MIL-R-15058G(SHIPS)
AMENDMENT-2
13 November 1967

MILITARY SPECIFICATION

RUBBER, SHAFT COVERING MATERIALS

(FOR MARINE PROPELLER SHAFTS)

FIGURE 1 - TAPER AND UNDERCUT ON SLEEVES FOR TYPE II AND TYPE III SHAFT COVERING.

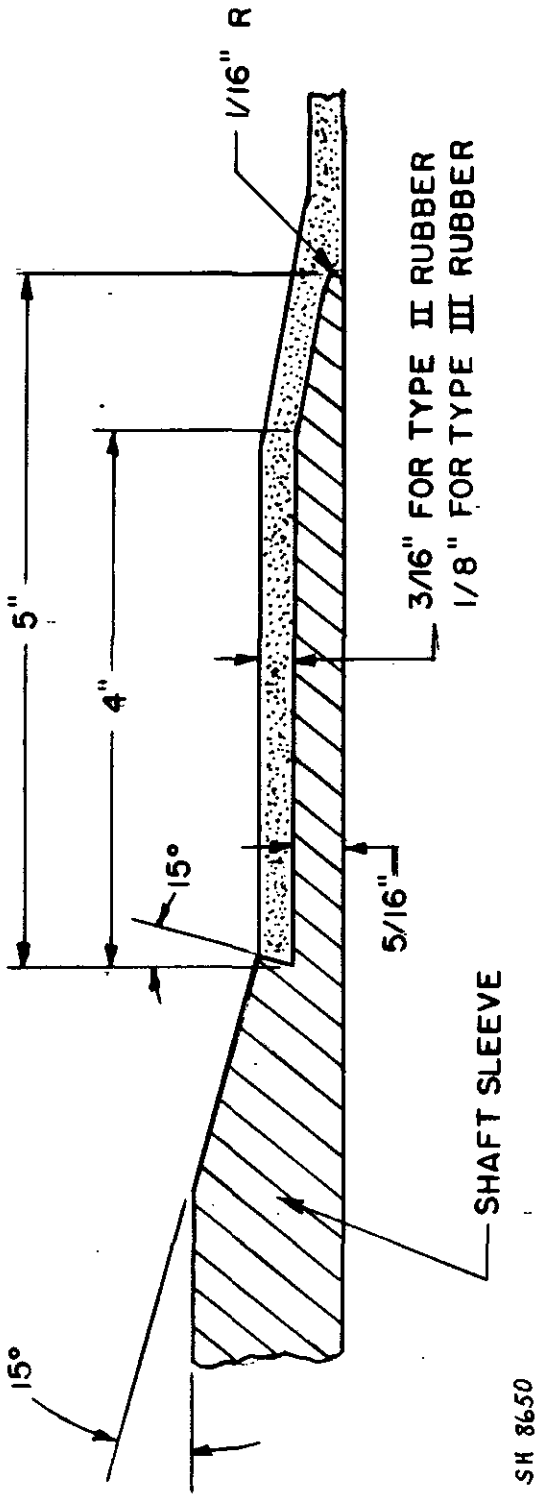
Page 2, paragraph 3.2.1, first sentence: Delete and substitute: "Bearing sleeves, on either end of the surfaces to be covered, shall have a tapered undercut surface as shown on figure 1."

Pages 4 and 5: Delete figures 1 and 2 and substitute attached figure 1.
